PEACH BOTTOM ATOMIC POWER STATION, UNIT NO. 2

AMENDMENT TO FACILITY OPERATING LICENSE

Amendment No. 19
License No. DPR-44

SAFETY EVALUATION BY THE OFFICE OF NUCLEAR REACTOR REGULATION
SUPPORTING AMENDMENT NO. 19 TO FACILITY LICENSE NO. DPR-44 AND
AMENDMENT NO. 19 TO FACILITY LICENSE NO. DPR-56

PHILADELPHIA ELECTRIC COMPANY PEACH BOTTOM ATOMIC POWER STATION UNITS 2 and 3
MANAGEMENT ORGANIZATION CHART
FIGURE 7.1-1

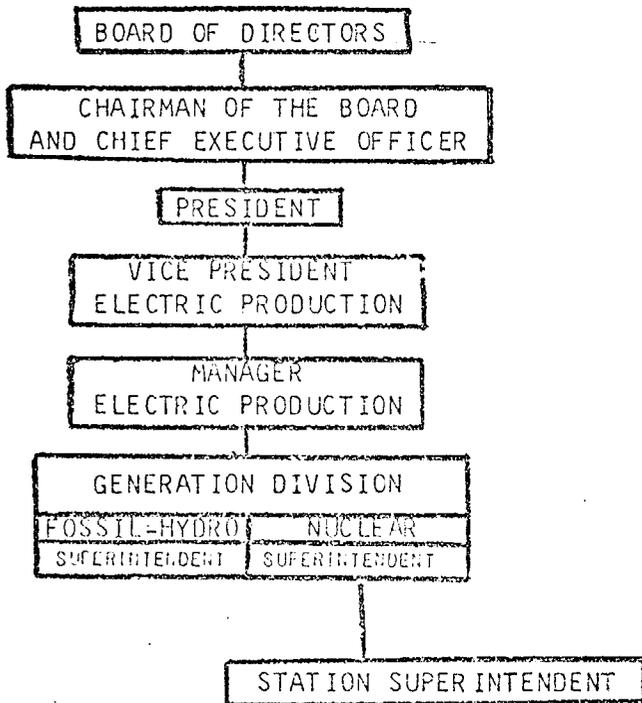
- A. The Plant Superintendent is responsible for the operation of the facility and to assure that the facility operates within the limits set forth in the environmental technical specifications.
- B. In all matters pertaining to operation of the facility and to the environmental technical specifications, the Plant Superintendent shall report to, and consult with the Superintendent, Nuclear Section of the Generation Division or, in his absence, the Superintendent, Fossil and Hydro Section of the Generation Division. The management organization is shown in Figure 7.1-1.

The changes proposed by the licensee involve purely administrative functions and will not affect the operation of the facilities. Specifically, restructuring occurred in the Electric Production Department and involved changes in the Peach Bottom Atomic Power Station management. The "General Superintendent, Generation Division" and the "Assistant General Superintendent, Generation Division" positions have been replaced functionally by the "Superintendent, Nuclear Section of the Generation Division" and the "Superintendent, Fossil and Hydro Section of the Generation Division". Additionally, a member of the Operation and Safety Review Committee, who formerly held the position of "Director - Environmental and Laboratory Division", was given the position of "Superintendent, Services Division".

PHILADELPHIA ELECTRIC COMPANY PEACH BOTTOM ATOMIC POWER STATION UNITS 2 and 3
MANAGEMENT ORGANIZATION CHART
FIGURE 7.1-1

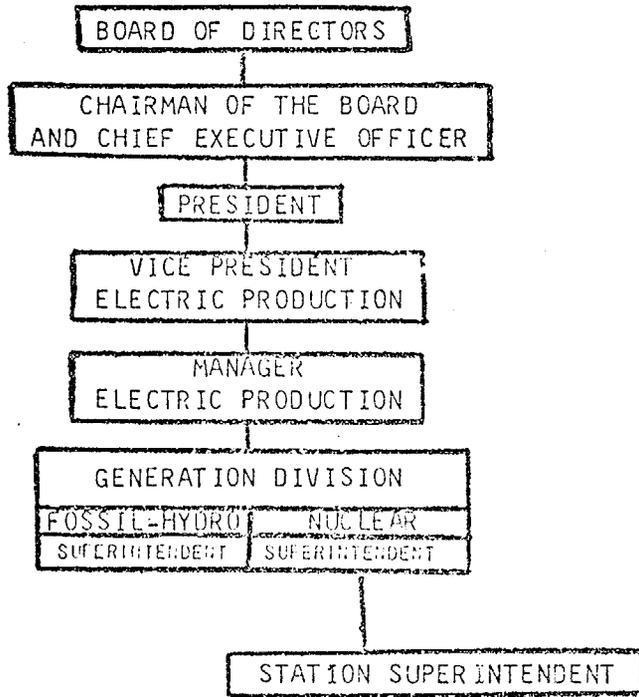
- A. The Plant Superintendent is responsible for the operation of the facility and to assure that the facility operates within the limits set forth in the environmental technical specifications.
- B. In all matters pertaining to operation of the facility and to the environmental technical specifications, the Plant Superintendent shall report to, and consult with the Superintendent, Nuclear Section of the Generation Division or, in his absence, the Superintendent, Fossil and Hydro Section of the Generation Division. The management organization is shown in Figure 7.1-1.
